DART AEROSPACE LTD		Work Order:	97864
Description: Crosstube Assembly (205/212/412 High Fwd)		Part Number:	D212-664-141
Inspection Dwg: D212-664-141 Rev: D		Page 1 of 2

DRAWING NO. D212-664-141	TITLE XTUBE ASSY (205/212/412 HI FWD)	REV. D	DART AEROSPACE LTD ENGINEERING ORDER		D.E.O. NO. D212-664-141-D-1	SHEET NO. SHEET 1 OF 2	SCALE NTS
DRAWN	CHECKED	MFG. APPR.	APPROVED	DE APPR.			
DATE 11.04.07	DATE 11.07.11	DATE 11.04.12	DATE 11/04/12	DATE 11.04.12

DRAWING NO. D212-664-141	TITLE CROSSTUBE ASS'Y (205 HI FWD)	REV. D	DART AEROSPACE LTD ENGINEERING ORDER	D.E.O. NO. D212-664-141-D-2	SHEET NO. SHEET 1 OF 1	SCALE NTS
DRAWN <i>IP</i>	CHECKED <i>ASS</i>	MFG. APPR. <i>AS</i>	APPROVED <i>MP</i>	DE APPR. <i>TH</i>		
DATE 11.07.15	DATE 11.07.20	DATE 11.07.21	DATE 11/07/21	DATE 11.07.21

DRAWING NO. D212-664-141	TITLE XTUBE ASSY (205/212/412 HI FWD)	REV. D	DART AEROSPACE LTD ENGINEERING ORDER		D.E.O. NO. D212-664-141-D-3	SHEET NO. SHEET 1 OF 1	SCALE NTS
DRAWN AJS	CHECKED 9P	MFG. APPR. 140	APPROVED 140		DE APPR. 140		
DATE 12.06.28	DATE 12.07.05	DATE 12.07.05	DATE 12.07.05		DATE 12.07.05

**D212-664-141/-141B
ASSEMBLY DETAIL**

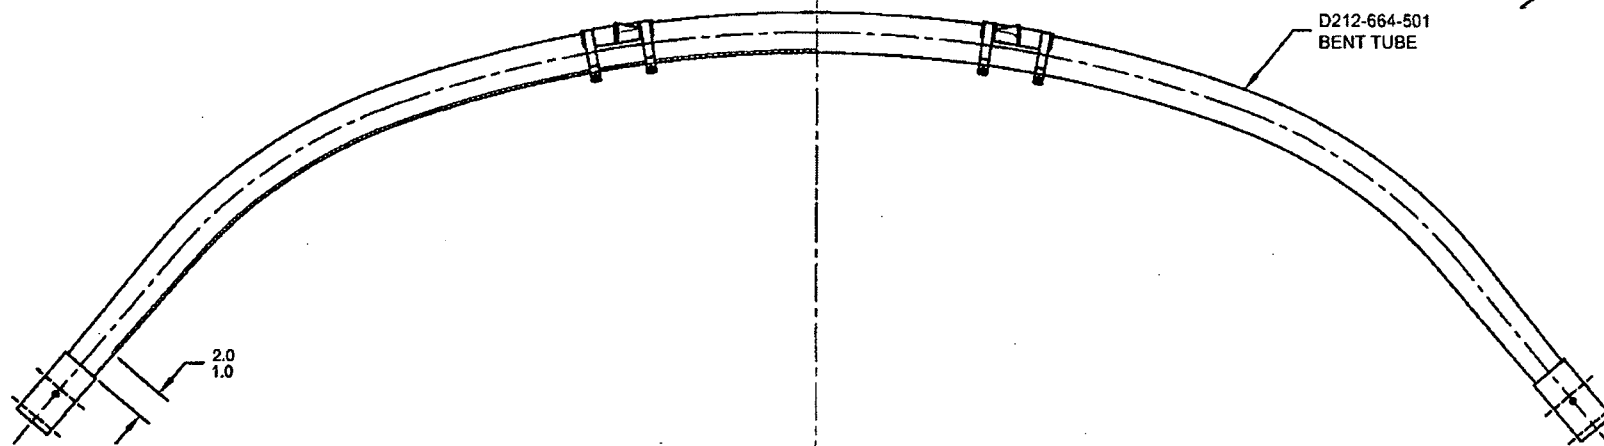
PURPOSE:

ADD AN INSPECTION WINDOW TO UNDERSIDE OF CROSSTUBE.

IS:

WAS:

MASK AREA PRIOR TO PAINTING,
REMOVE MASKING AFTER PAINT
AND APPLY CLEAR COAT
